ADDENDUM NUMBER ONE (1)

Project: Liberty Park Renovation – Re-Bid
Liberty Park Sports Complex
Madison, MS
PN: 22095

FROM: Dean Architecture, P.A.
661 Sunnybrook Road, Suite 140
Ridgeland, MS 39157
(601) 939-7717

STRUCTURAL ADDENDUM #1

SHEET NUMBER:
S101
FOUNDATION DETAILS

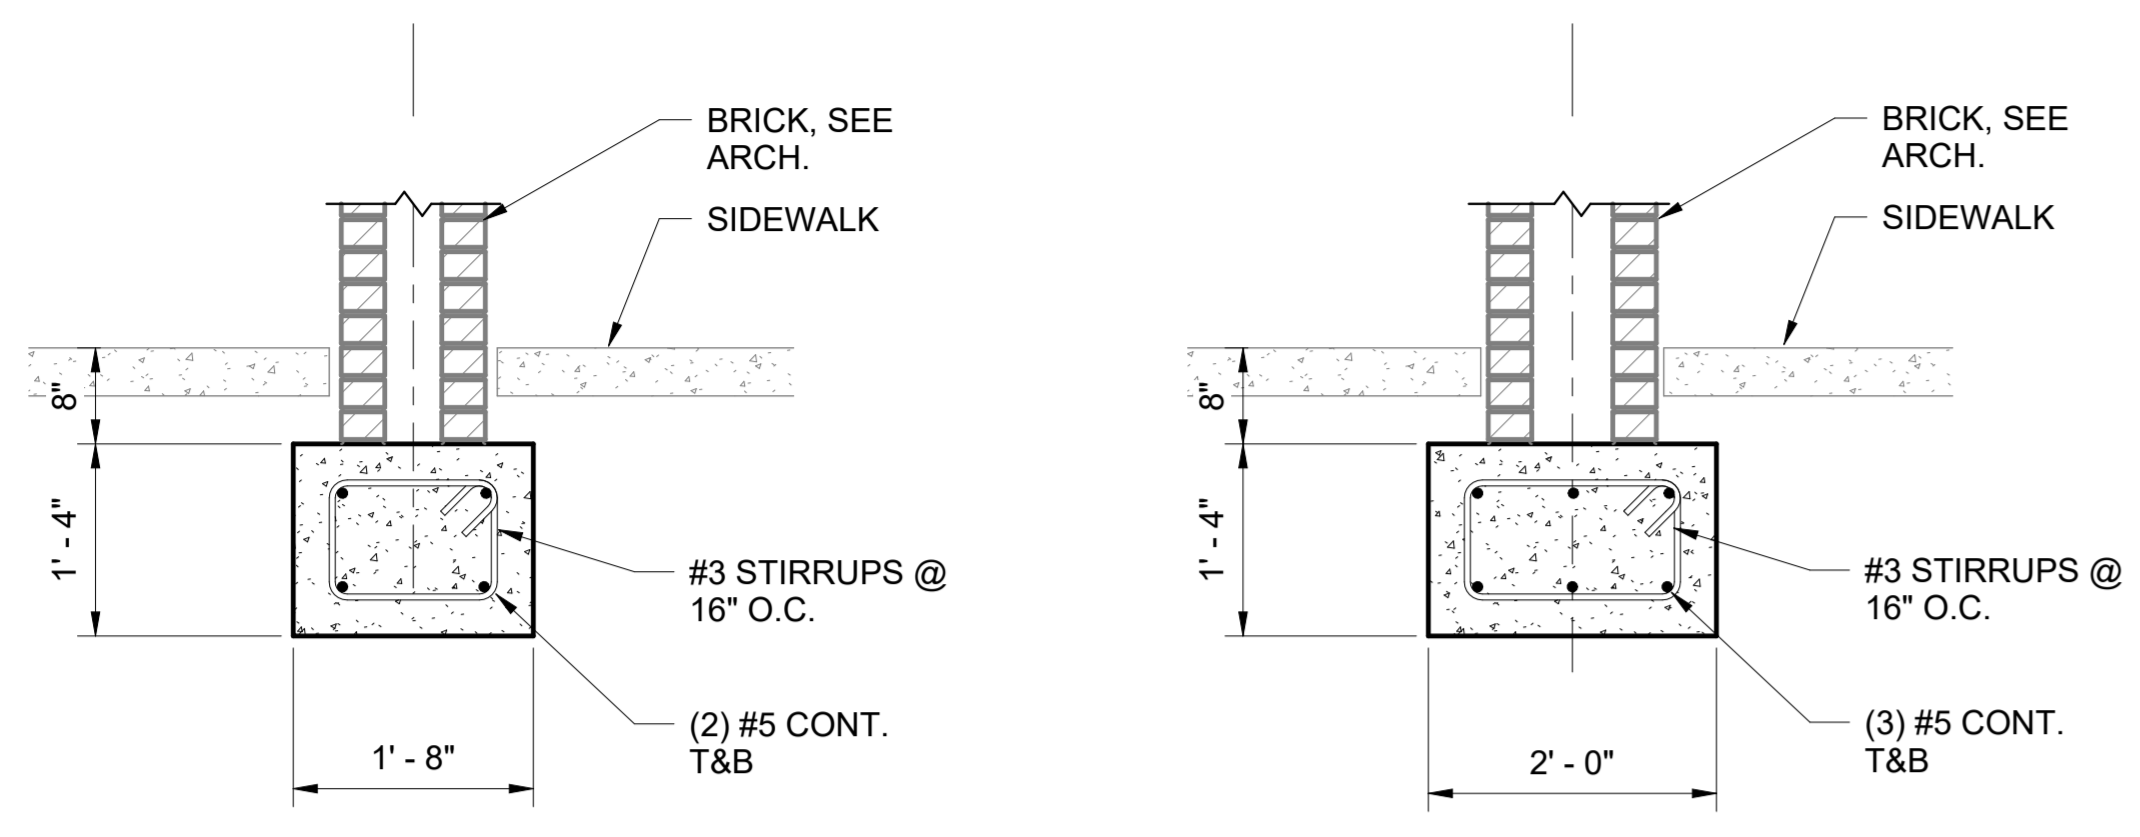
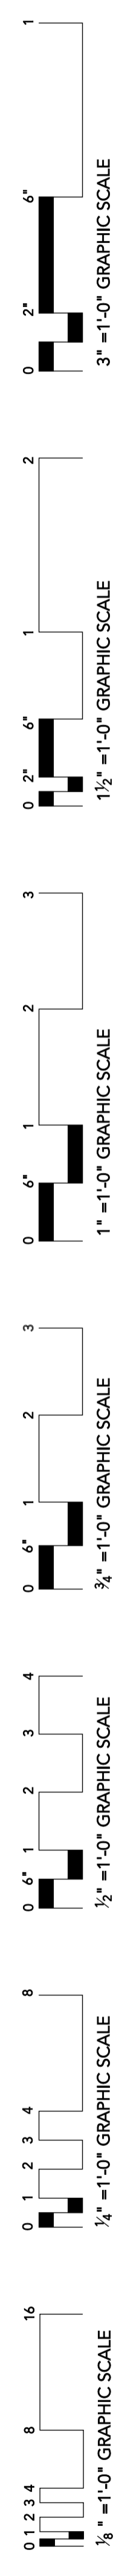
Item No. 1 Ref. Sheet S101 –Add attached sheet S101.

1
S101
DUGOUT VISION BARRIER FOOTING
3/4" = 1'-0"
REF. 5/A102

2
S101
BACKSTOP RENOVATION FOOTING
3/4" = 1'-0"
REF. 6/A102

- NOTES:
1. PROVIDE THESE DETAILS AT THE LOCATIONS REFERENCED ON THE ARCHITECTURAL DRAWINGS.
 2. PROVIDE FOUNDATIONS BETWEEN POSTS. CONTRACTOR SHALL ENSURE THAT THE EXISTING POST FOUNDATIONS ARE NOT UNDERMINED DURING CONSTRUCTION. TEMPORARY SHORING IS THE RESPONSIBILITY OF THE CONTRACTOR IF NECESSARY.
